Technical Service Bulletin

40 Noises from front of the vehicle when driving - e-tron

40 22 39 2066882/1 April 26, 2022.

Figure 1: Guide link hydro bushing, front suspension.

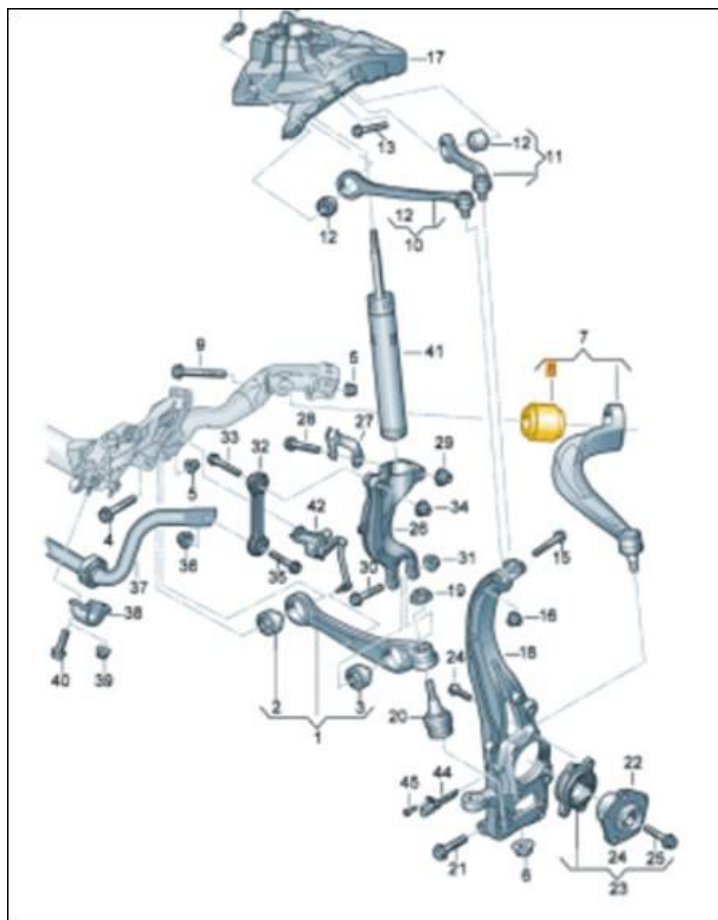
- Noises can be reproduced and are coming from:
 1. The guide link hydro bushing. Figure 1 (item 8, marked in yellow), or
 2. The drive train (electric motor, gearbox, driveshafts).

The rattling/clacking noises made by the guide link hydro-bushing are caused by an air bubble that is enclosed inside the bushing during the manufacturing process. When vibrations are induced in the axle by an uneven road surface (multiple brief hard knocks in quick succession), the high-frequency change in the bushing's internal pressure causes the volume of the air bubble to change. This can produce rattling/clacking noises under certain temperature conditions.

- Replace the guide link bushing on both sides with guide link bushing part number described in the parts table below.

The part numbers mentioned in this TSB are different than the ones listed in ETKA. Only use parts listed in this TSB, this includes superseding part numbers!		
Part Number	Part Description	Quantity
See ETKA	Fasteners, Bolts, Nuts, and Screws as needed per the Repair Manual	See ETKA/ELSA
4KC407183	Hydro mounting (Hydro bushing)	02
